Addendum to IFB

IFB NUMBER: IFB 24-065/MR
IFB TITLE: Jefferson County Doggett Park Midway Rehabilitation
IFB DUE BY: 11:00 am CT, Wednesday, November 20, 2024
ADDENDUM NO.: 1
ISSUED (DATE): November 14, 2024

REV 1 Addendum #1 Modifications
11-13-2024

JEFFERSON COUNTY
 ENGINEERING DEPARTMENT
 JEFFERSON COUNTY COURTHOUSE
 1145 PEARL STREET, 5TH FLOOR
 BEAUMONT, TEXAS 77701
 PHONE: (409) 835-3584 FAX: (409) 835-8718
 PROJECT: DOGGETT FORD PARK
 MIDWAY ASPHALT REHABILITATION
 SHEET 5 OF 9 SHEET QUANTITIES
 DRAWN BY: G.K.
 CHECKED BY: M.F. 05

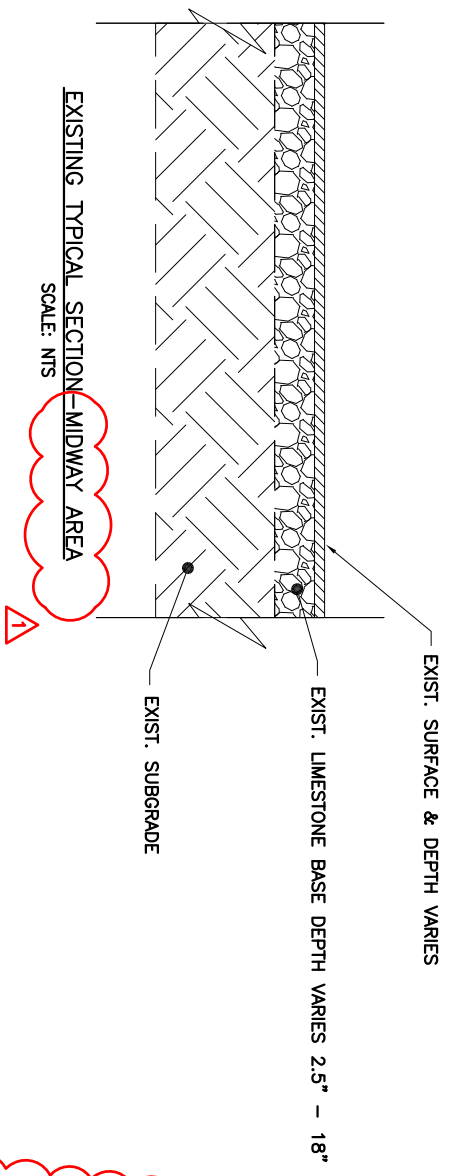
General Site Information
 SQUARE YARDS OF SURFACE (SY) 39,900.0
 EXCAVATION (INCHES) ~~2.25~~ **2.75**
 LIME STABILIZATION (INCHES) 8.0
 CEMENT ~~HMAC (INCHES)~~ 2.00

EXISTING TYPICAL SECTION - UTILITY ISLAND AREA
SCALE: NTS

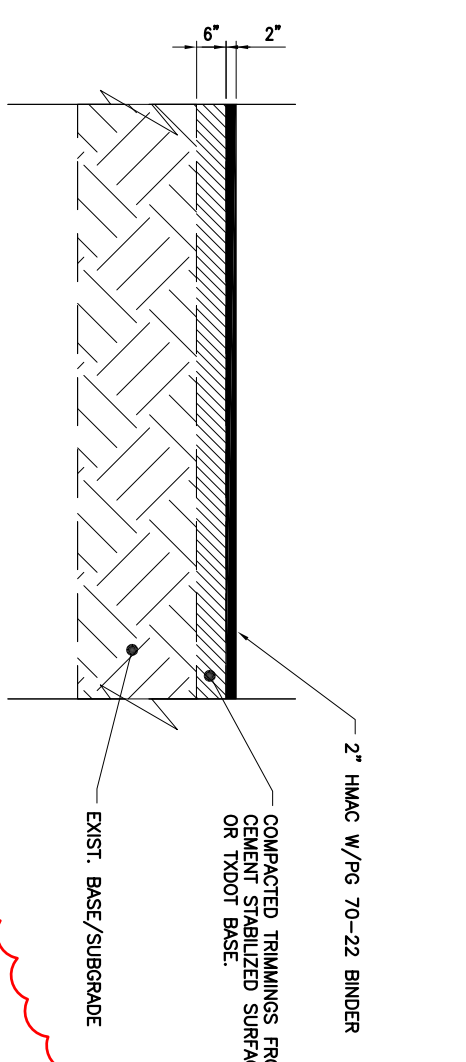
Answer: See added "utility island" detail on to Project Plans Sheet 8 (Attachment D).

Answer: See added “utility island” detail on Project Plans Sheet 8 (Attachment D).

REV 1 ADDENDUM #1 MODIFICATIONS
ADDITION OF UTILITY ISLAND
DETAILS & OTHER MISC. MODS
11-13-24
